**TOWN OF BAY HARBOR ISLANDS
MORRIS N. BROAD COMMUNITY CENTER
1175 95TH STREET
BAY HARBOR ISLANDS, FL 33154**

DESIGN REVIEW BOARD

**May 7, 2024
7:00 PM**

FINAL AGENDA

1 TYP. A/C SCREENING PLAN CALLOUT -DRB Copy 1
DRB.10 Scale: 1/4" = 1'-0"

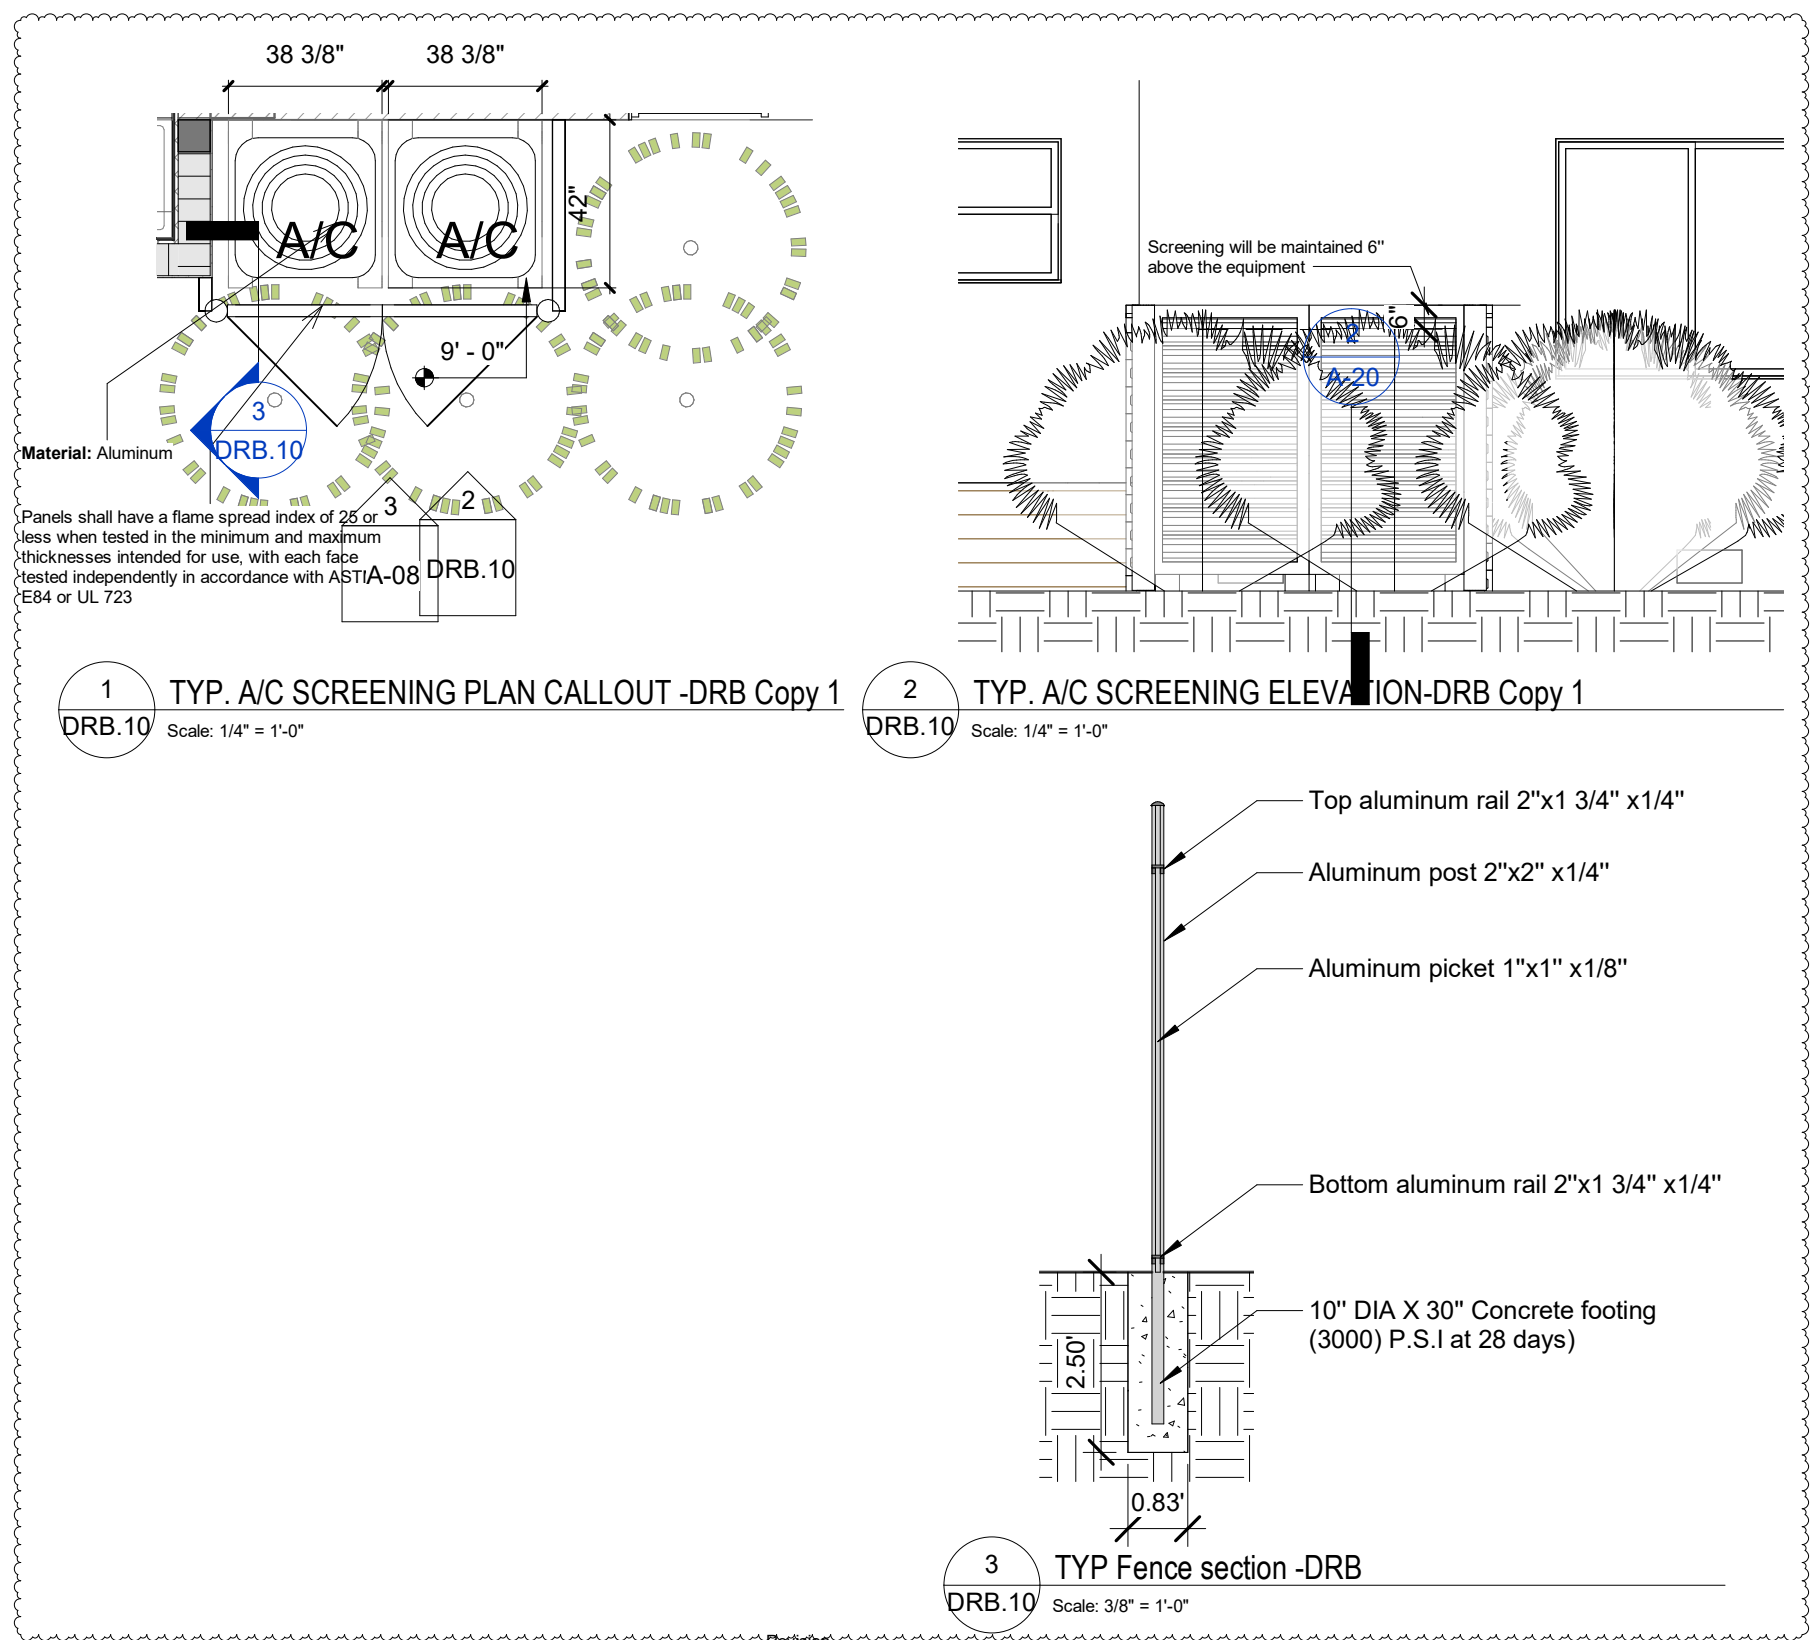
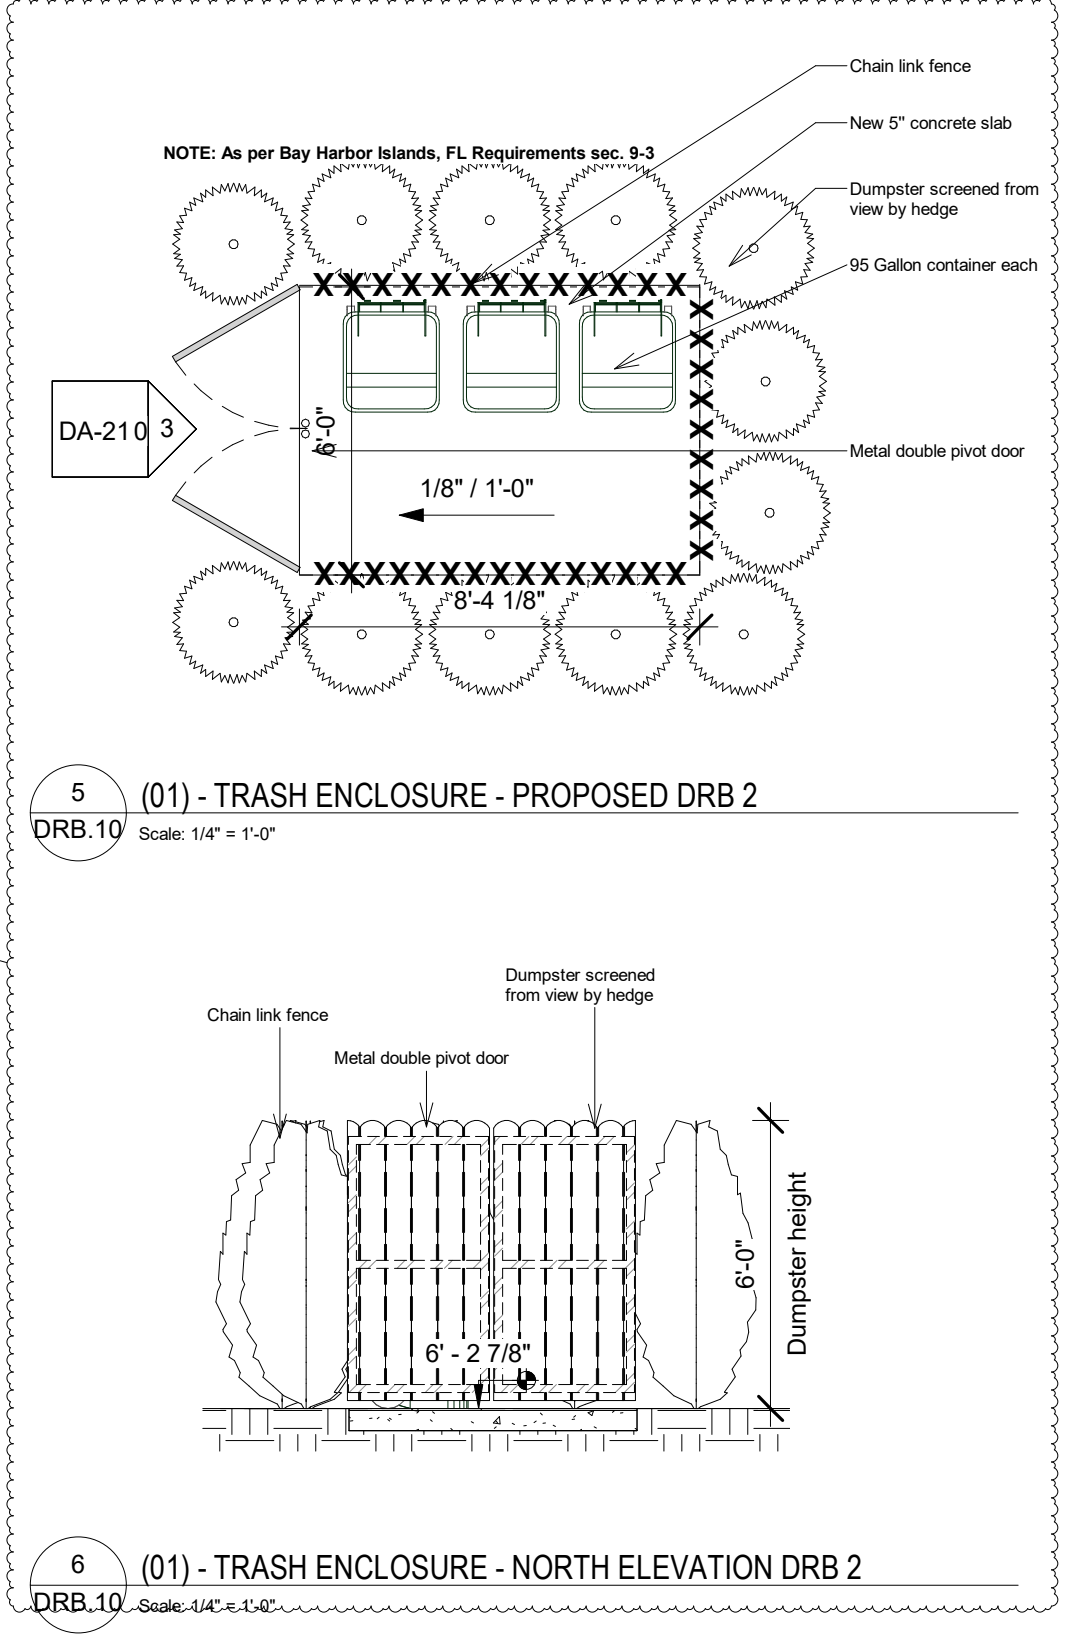
Revision Number	Revision	Date
49	3.The new A/C units appear to be elevated to meet FEMA / FBC requirements, however, they need to be screed. The code requires a physical barrier (Fence/wall) with supplemental landscaping. (Landscaping alone is not sufficient). Call out type of proposed screening including material, color and height.	09-14-2023
62	12.Provide information on existing/proposed trash and garage disposal storage system including the proposed required screening.	09-14-2023
